26/00081/DISCON

Supporting information from Bloor Homes in response to PRow comments:

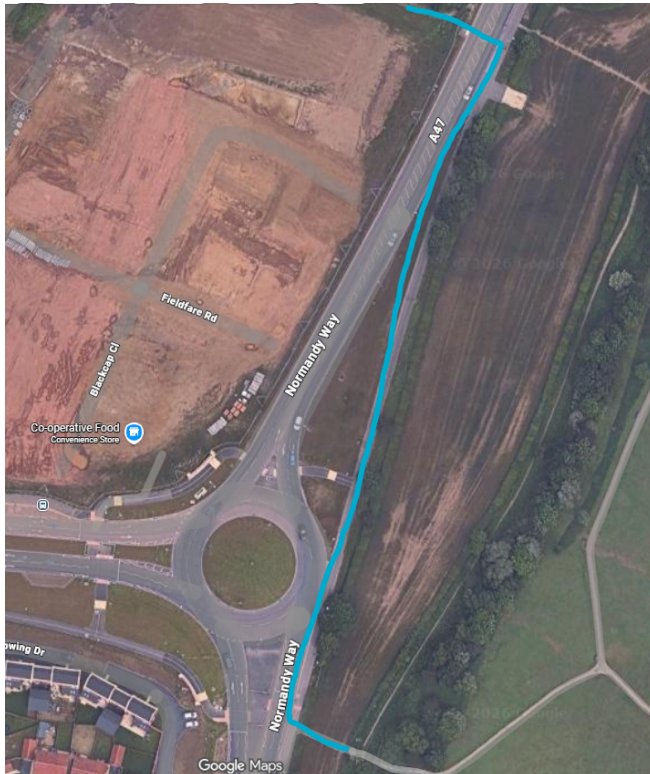
Regarding the diversion I would state that there is a footpath which leads on the other side of the road where the footpath comes through towards Normandy way. This is adequately surfaced and leads the pedestrians across a safe crossing and onto the diverted route.

- I have attached the kerbing plan which shows where the new pathway is being installed and that the kerbs are dropped.
- I have attached the most up to date landscaping for you.
- I have attached a plan which shows the route which we would expect pedestrians to take along the other side of Normandy Way which is more natural and connects with the current pathway.
